Network PTZ Dome Camera Firmware

Version: V5.5.2

Release Note

- 4) Newly add Face Detection**

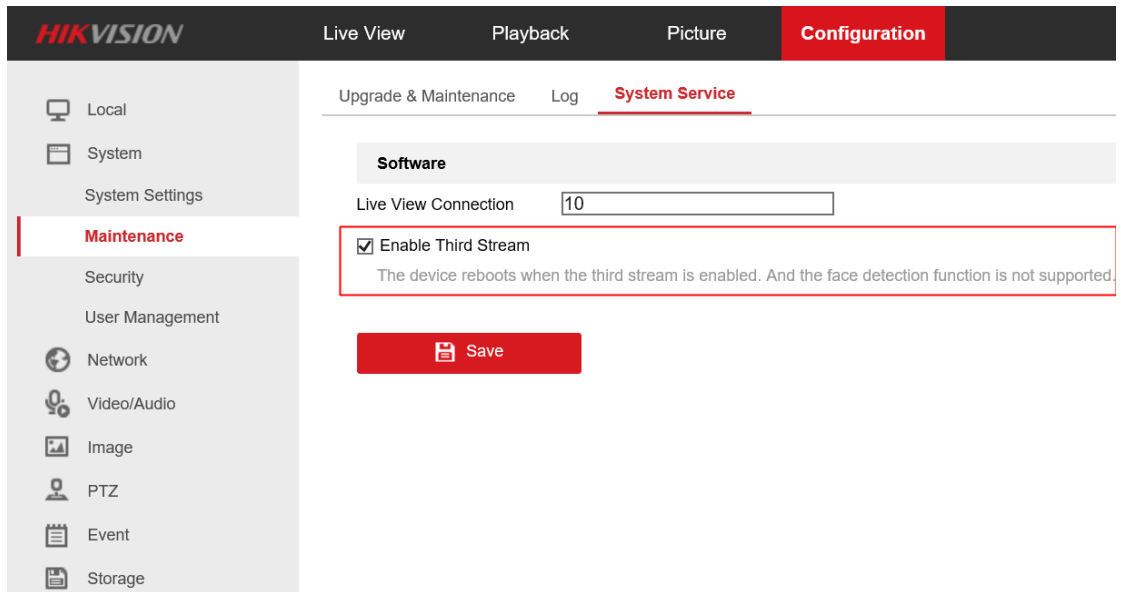
PTZ Cameras support Face Detection. But Face detection is mutually exclusive with third streams in some products, including PTZ-Nxxx, DS-2DE2xxx, DS-2DE3xxx, DS-2DE41xx, DS-2DE42xx, DS-2DE51xx, DS-2DE5225IW-AE, DS-2DE71xx. Third Stream can be enabled and disabled on System Service interface.
